Re: QuikTrip 7001, Albuquerque
Matkin Hoover Job No. 7001.01

TCL No. K10D070

This letter and its attachments serve as a response to comments received on May 16th, 2024, concerning the above referenced project.

Comment 6:

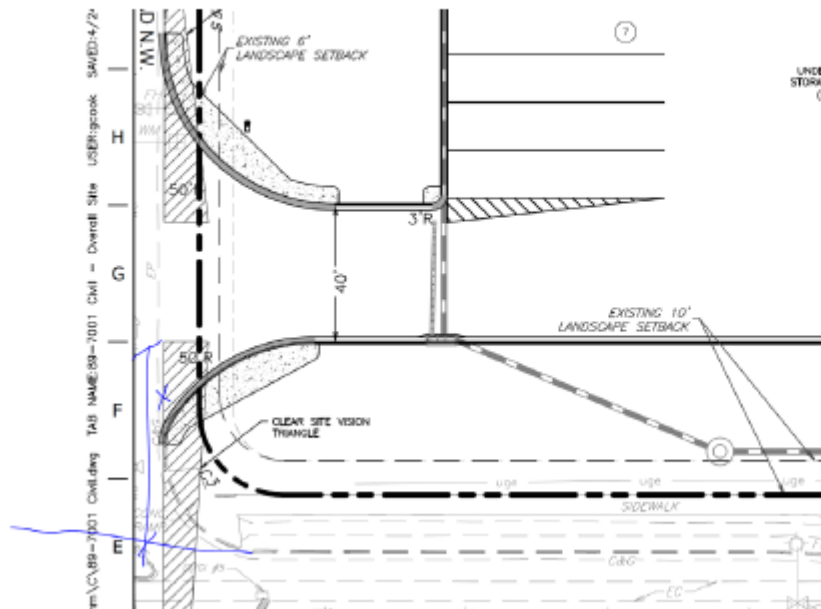
The minimum distance from the intersection to site access off Saul Bell Rd. is 75 ft. please show this dimension on the site plan.

Concur. Requested Driveway shifted plan north to accommodate 75ft clearance.
